**ADDENDUM NO. 3**

April 19, 2016

Plans & Specifications for: **Gilmore Playground, Waltham, MA**

This Addendum No. 3 is to modify, correct and/or supplement the Plans and Specifications.

**1** KOMPAN CUSTOM PALACE – FOOTING PLAN & LAYOUT  
N.T.S.

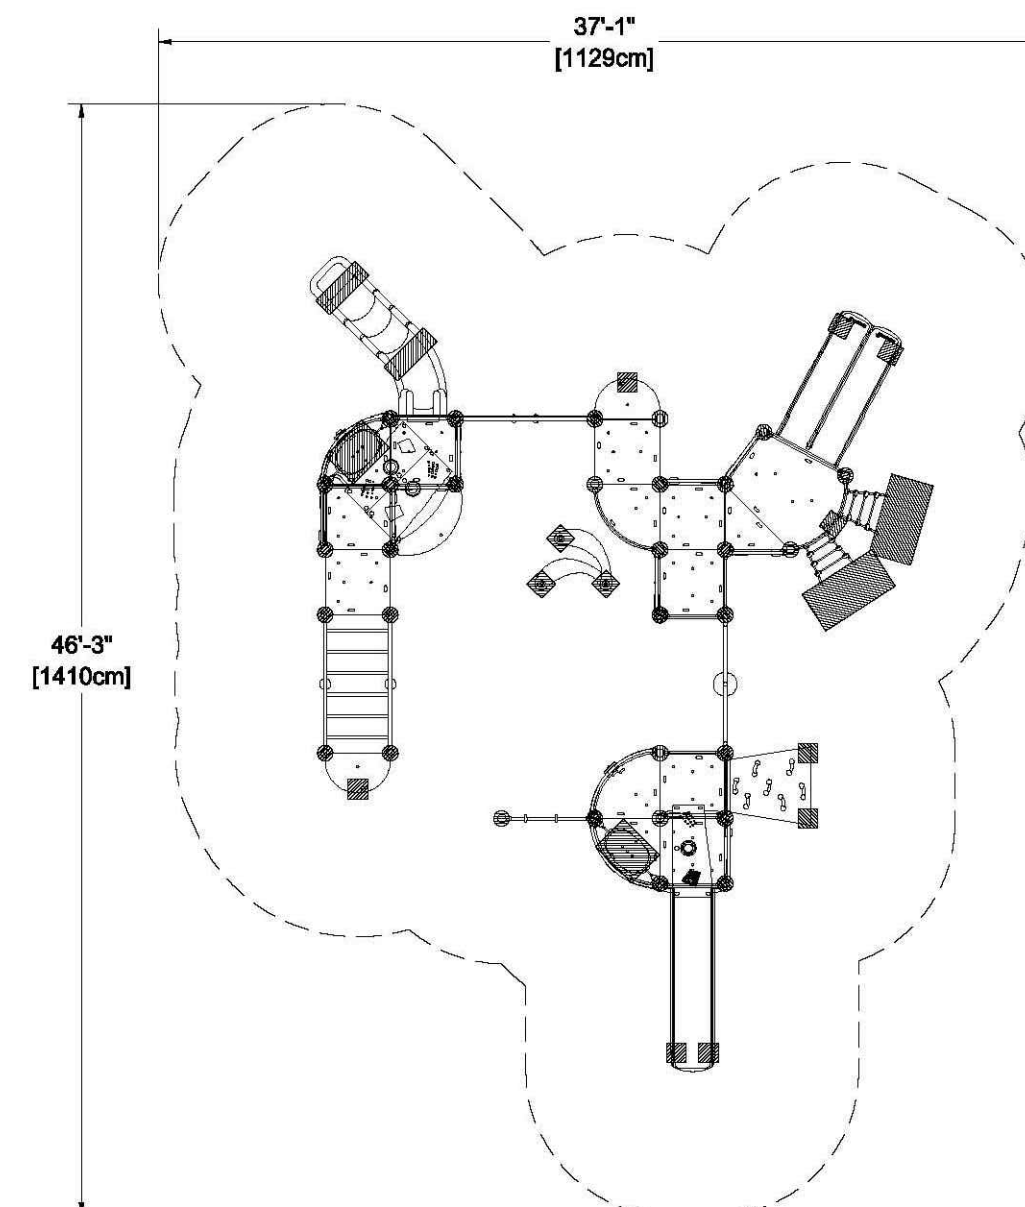
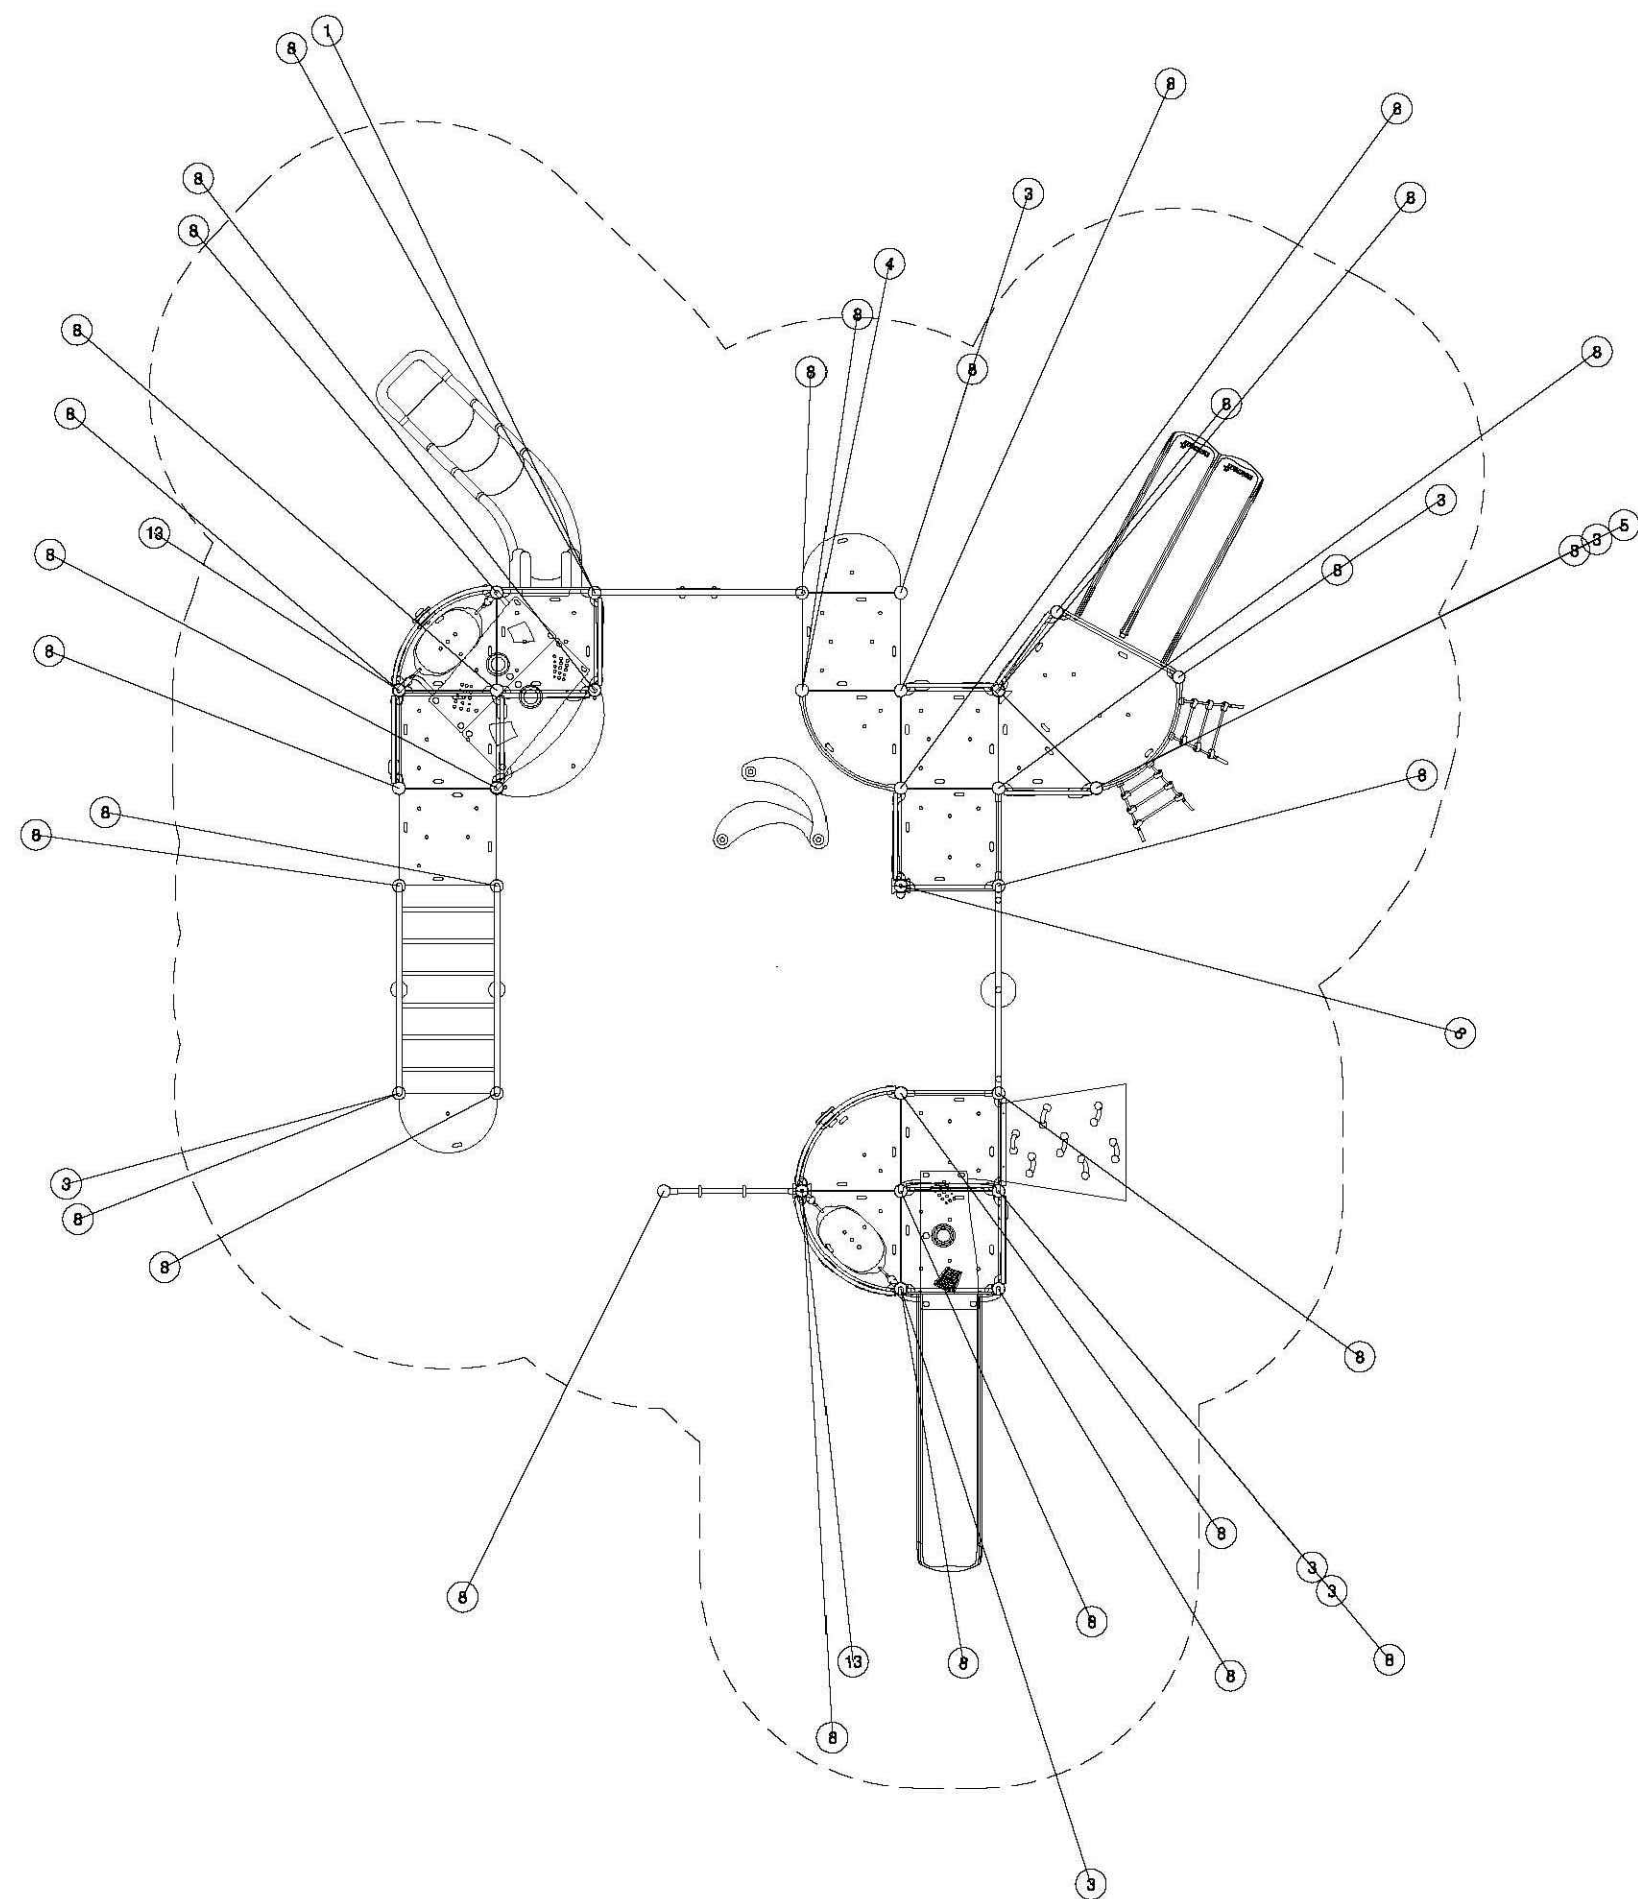
**ITEM NO. 6 Revision to Drawing L-16: Revision to Kompan Footing Layout**

FOOTING/LAYOUT REVISION PER ADDENDUM #3	04/18/16
---	----------

1 KOMPAN "PALACE" FOOTING DETAILS  
 1" = 1'-0"

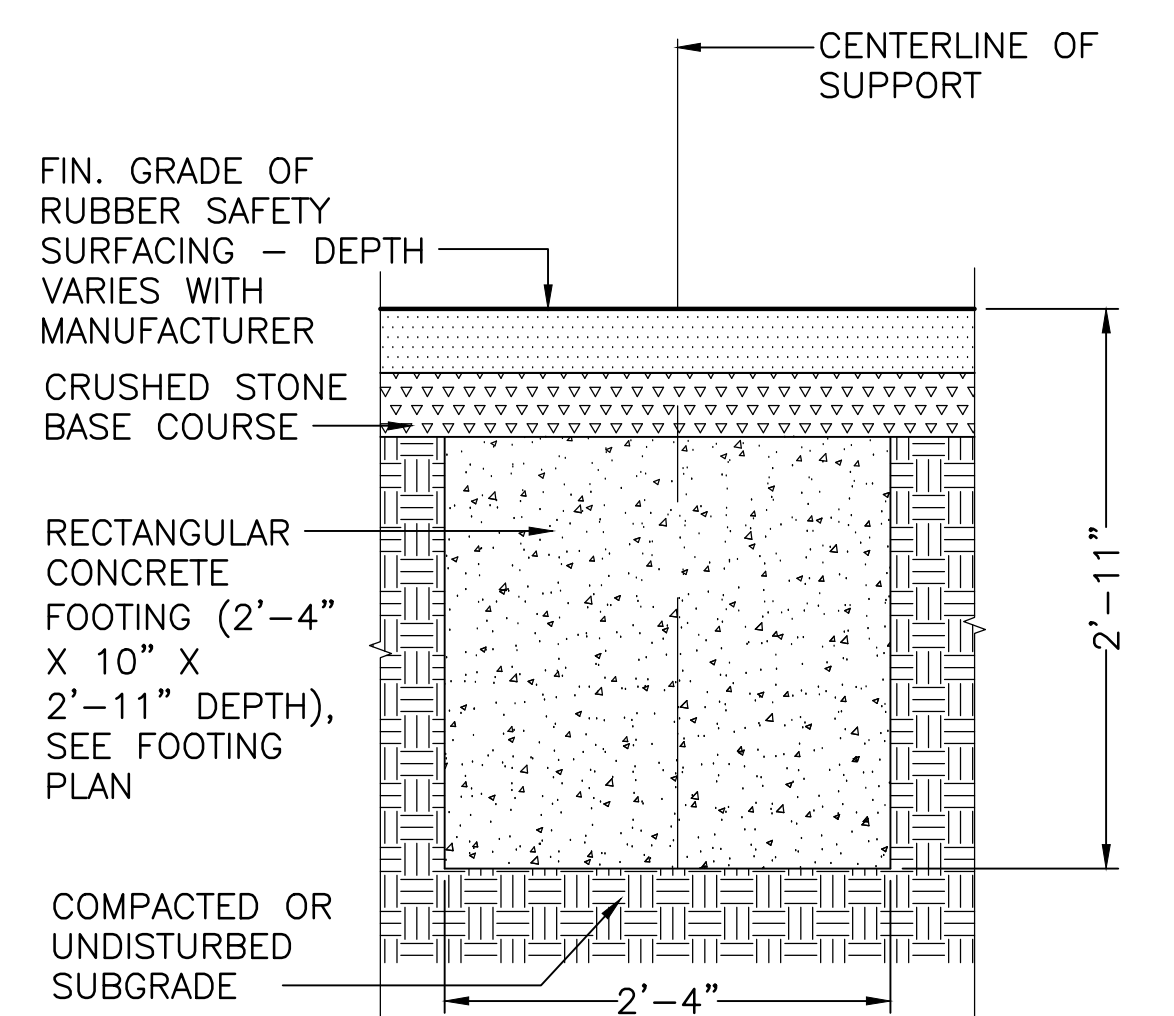
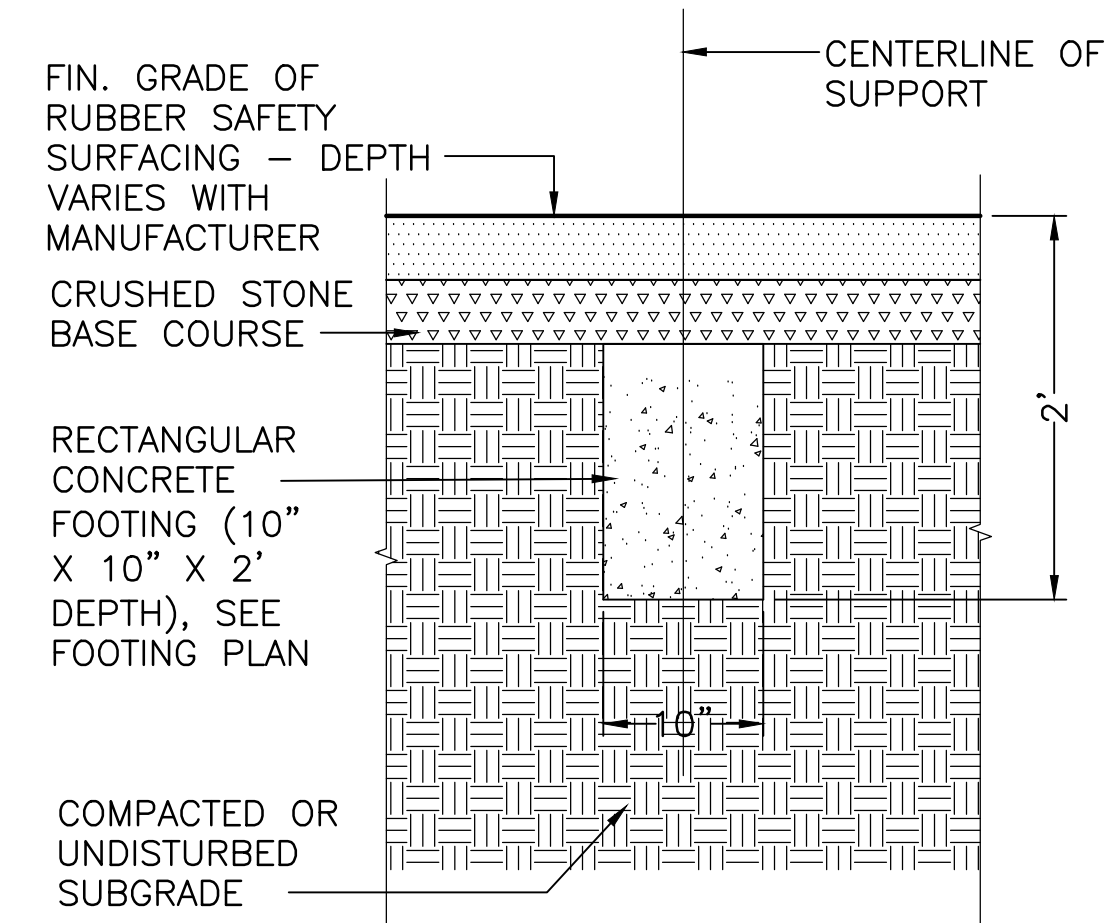
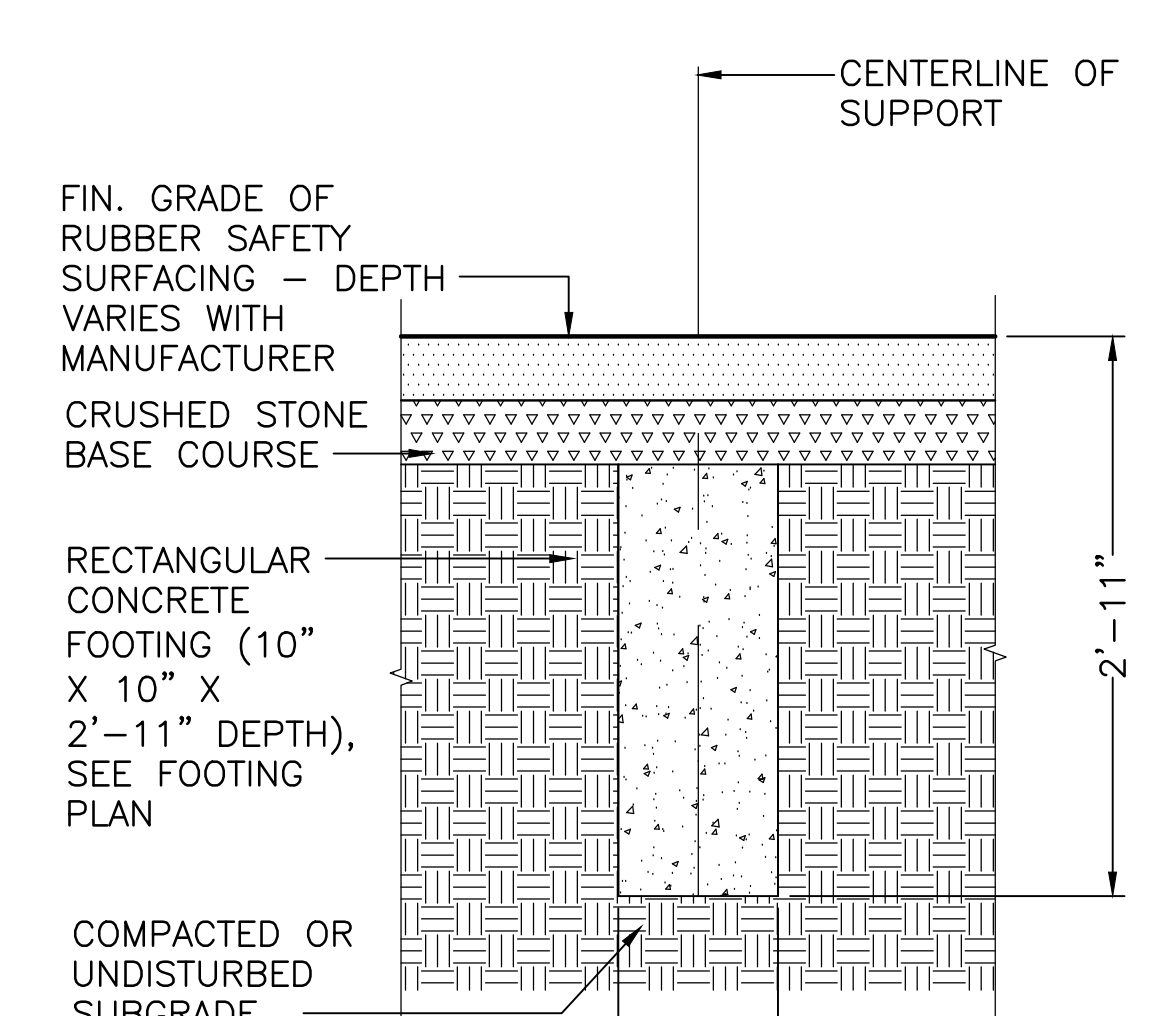
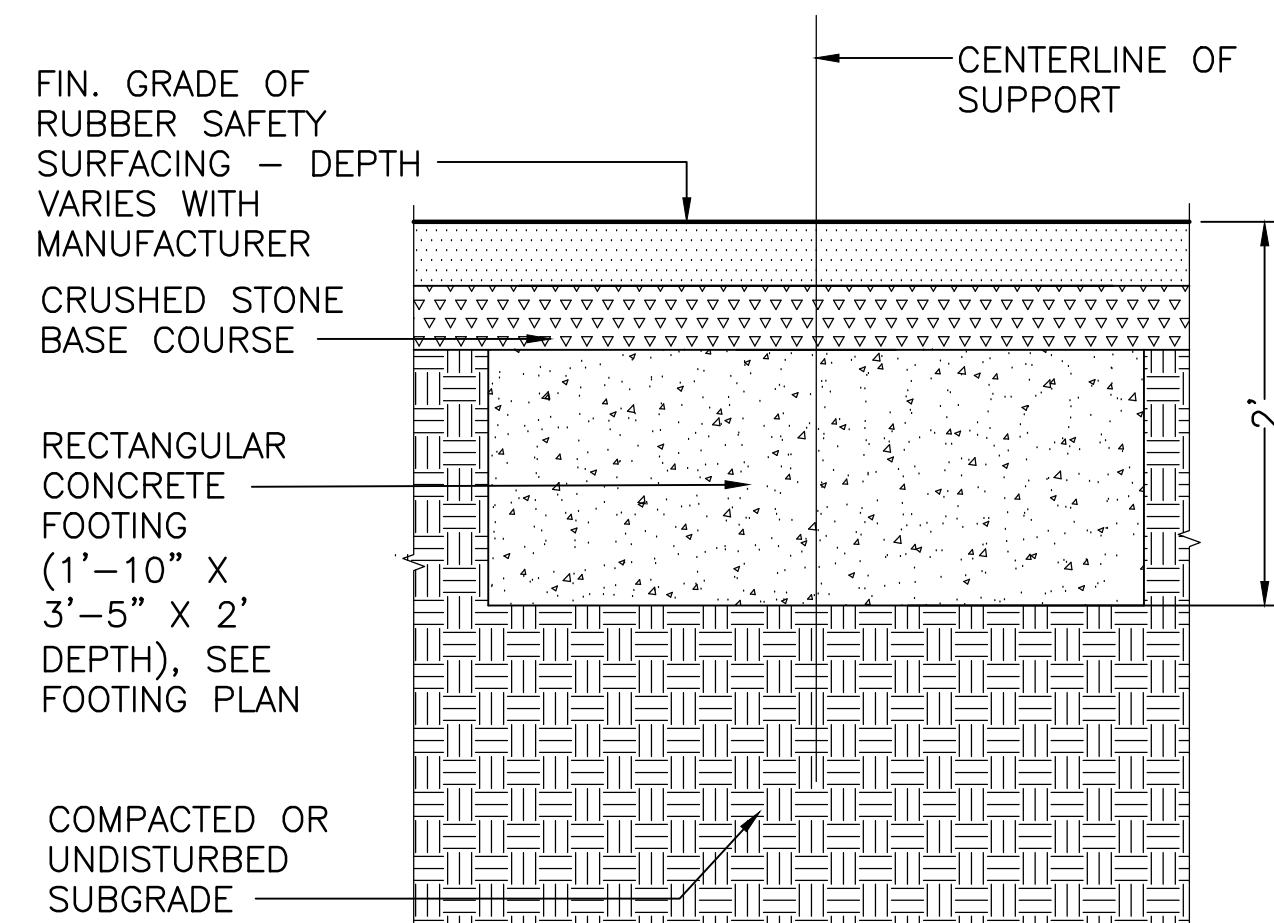
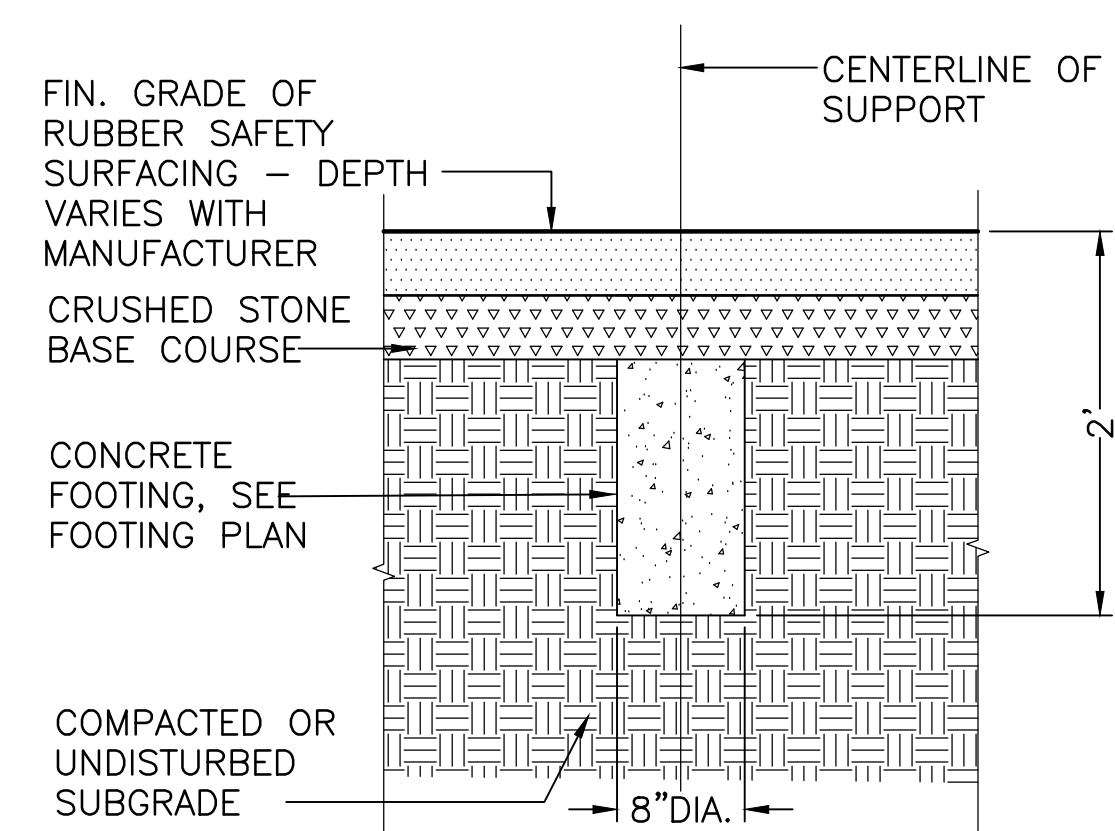
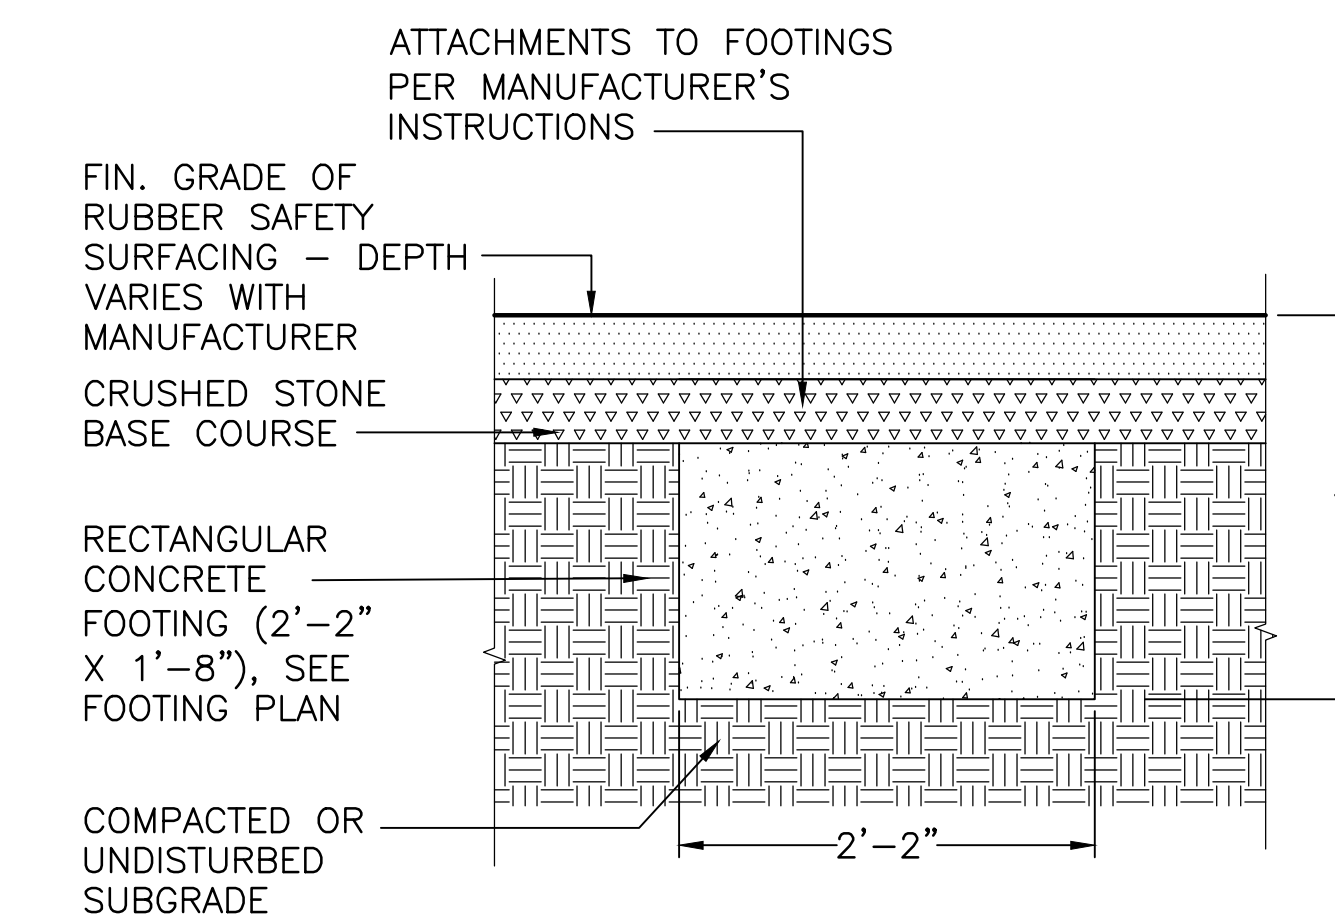
**ITEM NO. 7 Revision to Drawing L-17: Revision to Kompan Footings**

No.	Description	Date
1	FOOTING REVISIONS PER ADDENDUM #3	04/18/16
